NORTHWEST HILLS REGIONAL ANIMAL FACILITY

S/P+A PROJECT NO. 17.105

DATE: May 7, 2021

The following changes to the Drawings and Project Specifications shall become a part of the Drawings and Project Specifications; superseding previously issued Drawings and Project Specifications to the extent modified by Addendum No. 2.

A100

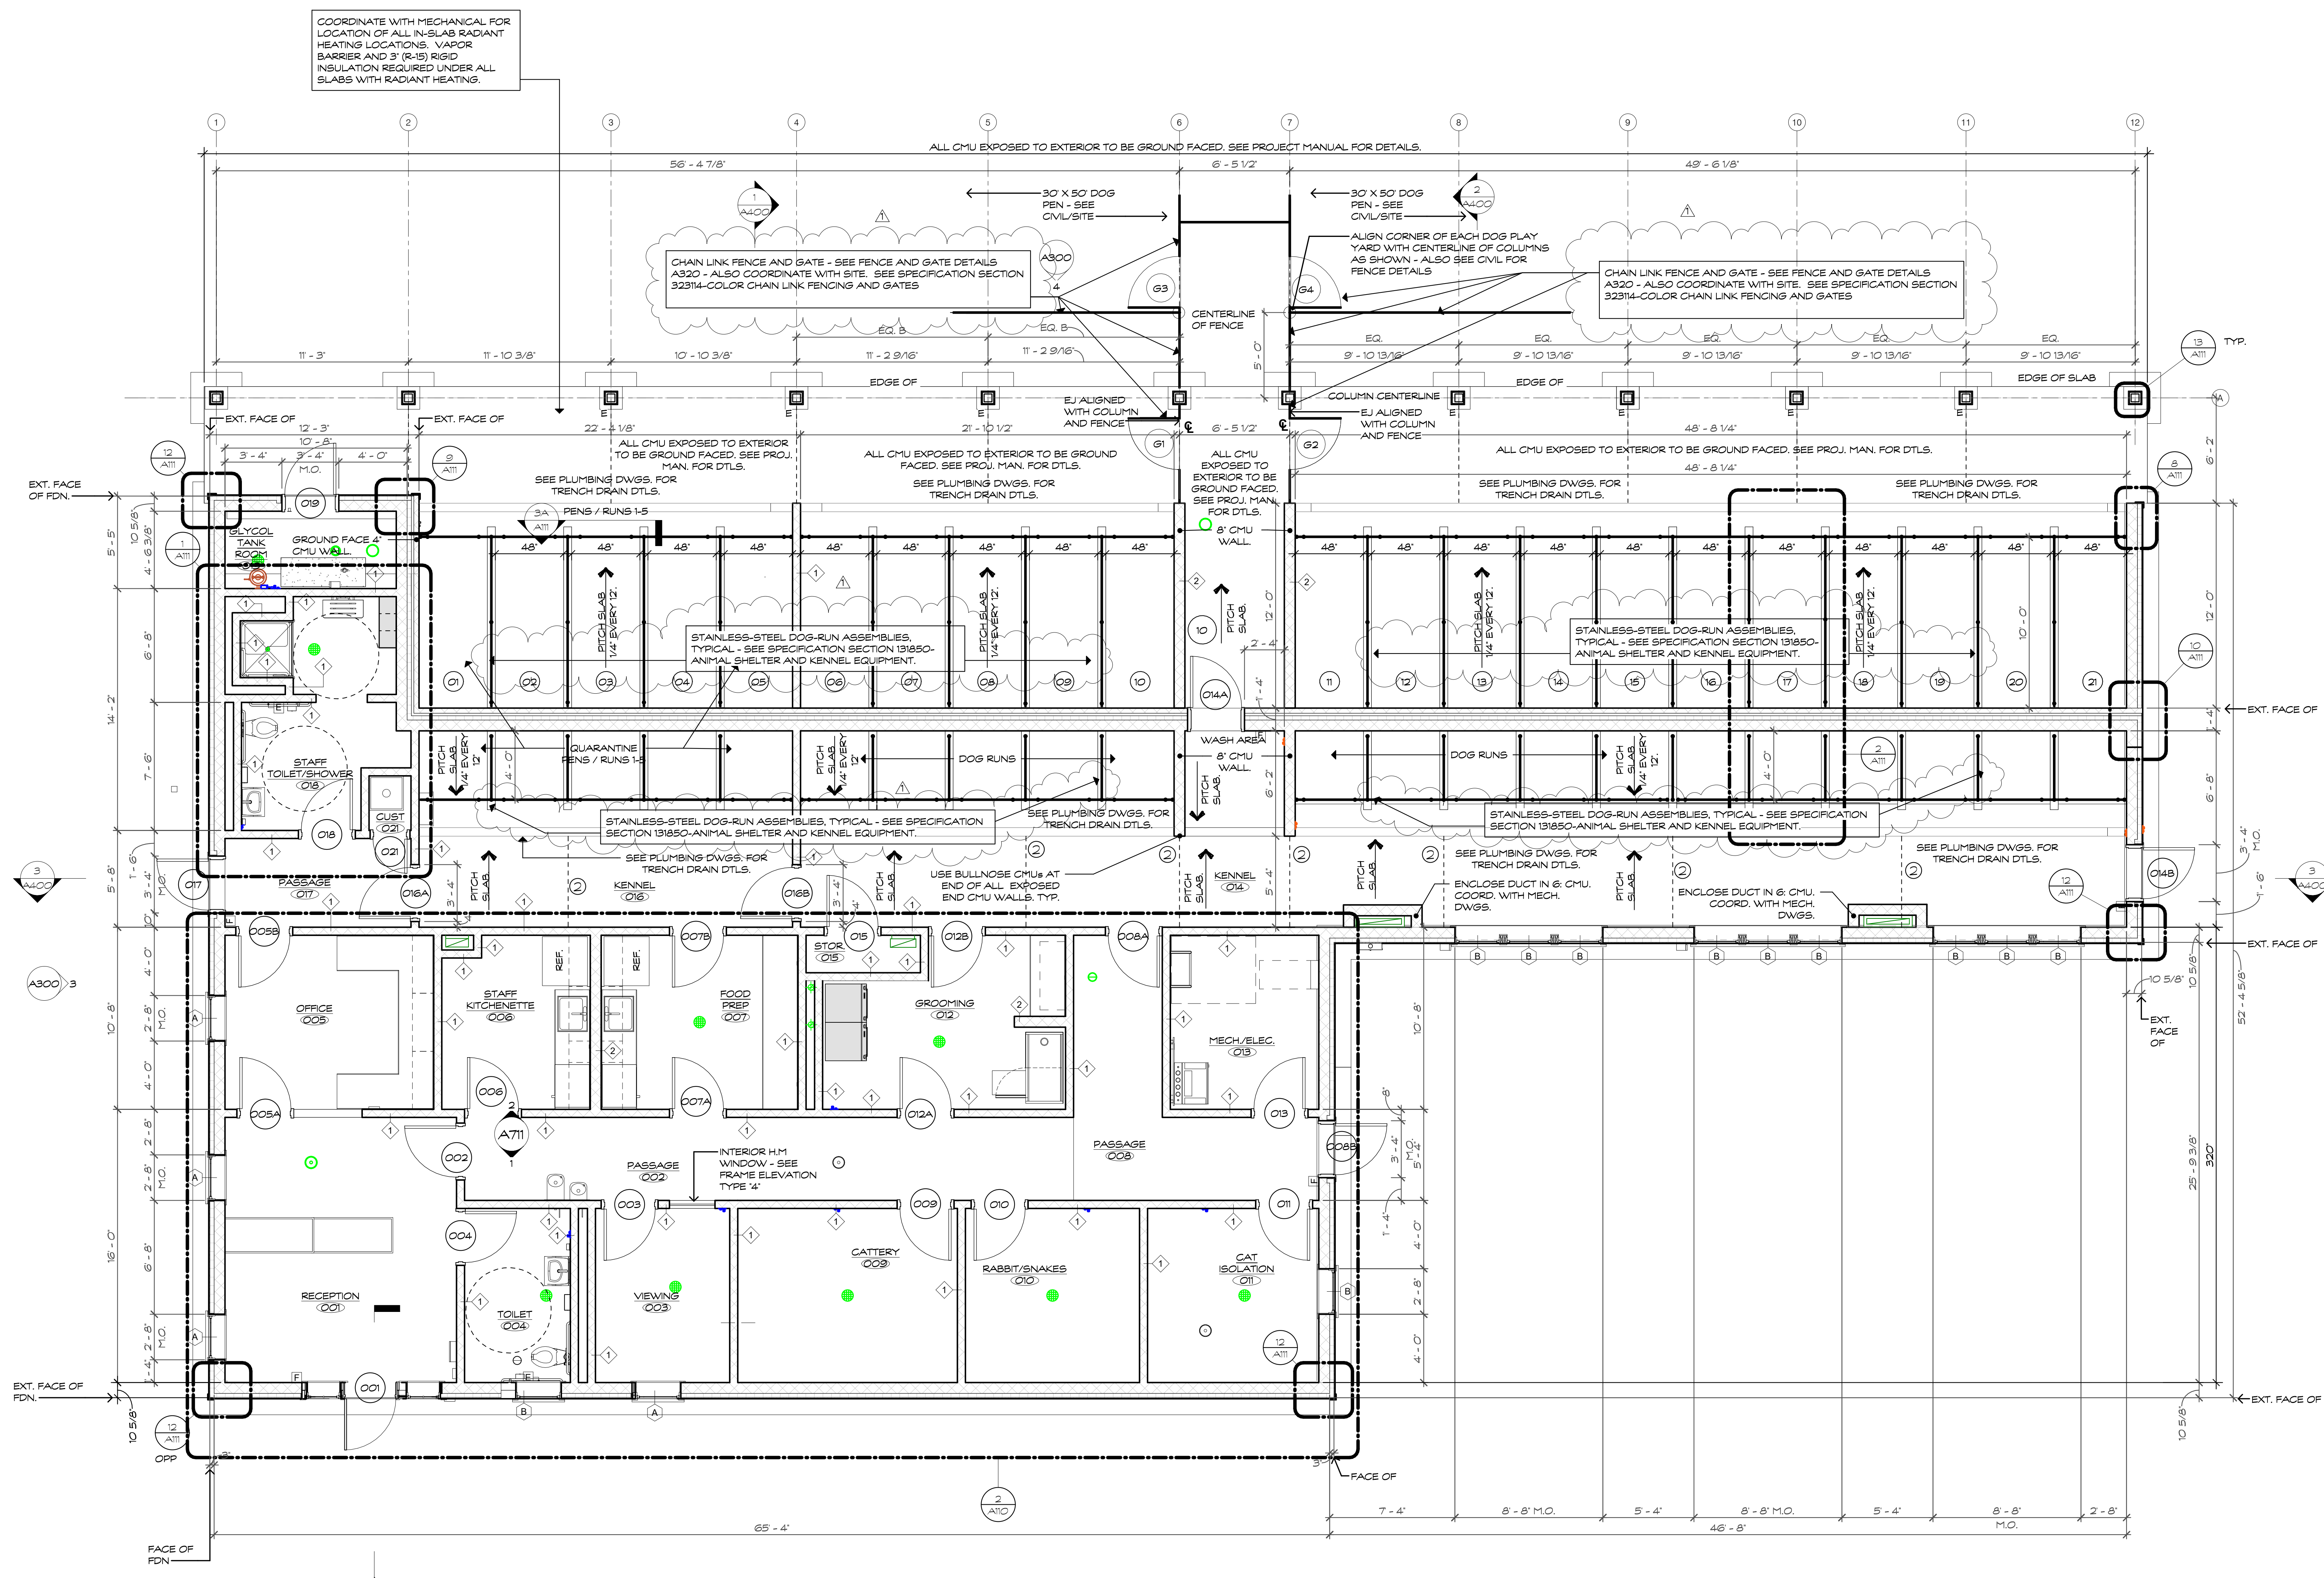
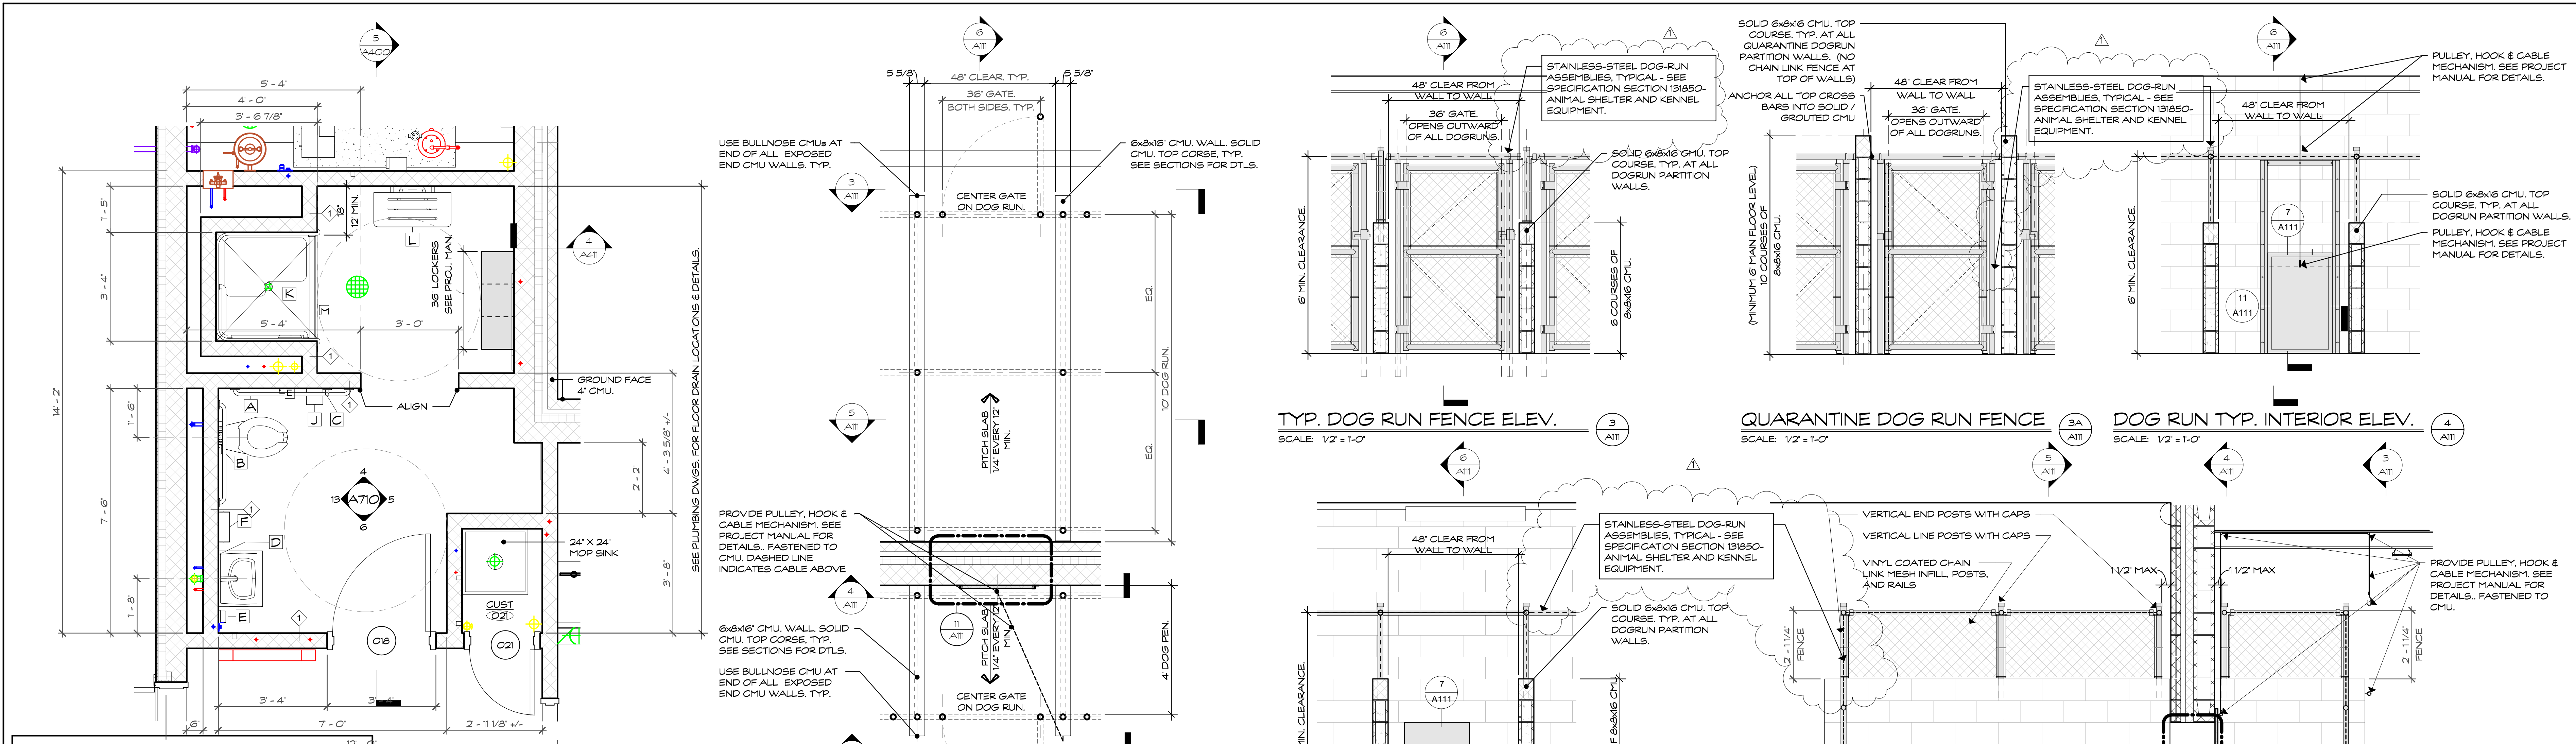
Revision	Description	Date	Revised By
1	DOG-RUN/FENCE UPDATE	05/07/21	BV

CHAIN LINK FENCE AND GATE - SEE FENCE AND GATE DETAILS A320 - ALSO COORDINATE WITH SITE. SEE SPECIFICATION SECTION 32314-COLOR CHAIN LINK FENCING AND GATES

STAINLESS-STEEL DOG-RUN ASSEMBLIES, TYPICAL - SEE SPECIFICATION SECTION 191850-ANIMAL SHELTER AND KENNEL EQUIPMENT.
